DEPARTMENT OF PLANNING AND ZONING

August 26, 2016

RE: DSUP2015-00026
Oakville Triangle Block A-1
Completeness Plan #2

Ex. Stairway Identification Sign

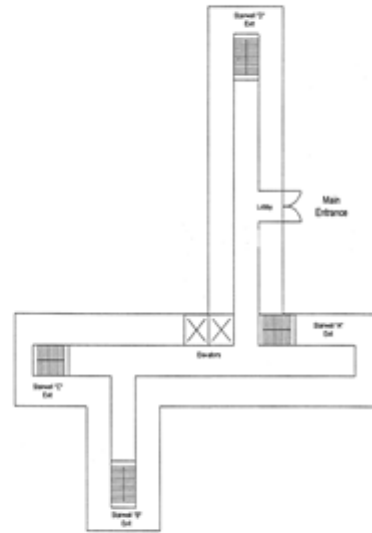
40. Provide Stairway Identification. Stairway identification signs shall be provided at each landing in all interior exit stairways connecting more than three stories. Stairways shall be identified by letter designation starting next to the main entrance with "A" and continuing in a clockwise or left to right pattern using consecutive letters of the alphabet for each additional stairway. Two copies of the stairway signs shall be submitted to the fire official for approval before occupancy.

Stairway signs shall designate the stairway letter, state the floor level, the level of exit discharge, and if there is access or no access to the roof regardless if the access door or roof hatch locks. The bottom of the sign shall be located five (5) feet above the floor landing in a position that is readily visible when the stairwell door is opened or closed. The signs must have lettering that is a minimum of 2 inches but no greater than 4 inches in height. This information may be stenciled directly onto the wall but all lettering must be of a color contrasting with the background stairway wall color.

In buildings greater than three stories where there is no graphic representation of the building footprint, a simplified building schematic must be display in the lobby. The simplified building footprint shall be an overhead view of the building exterior and the general layout of the lobby of the first floor. Stairways shall be denoted by letter as required.

Acknowledged by applicant.
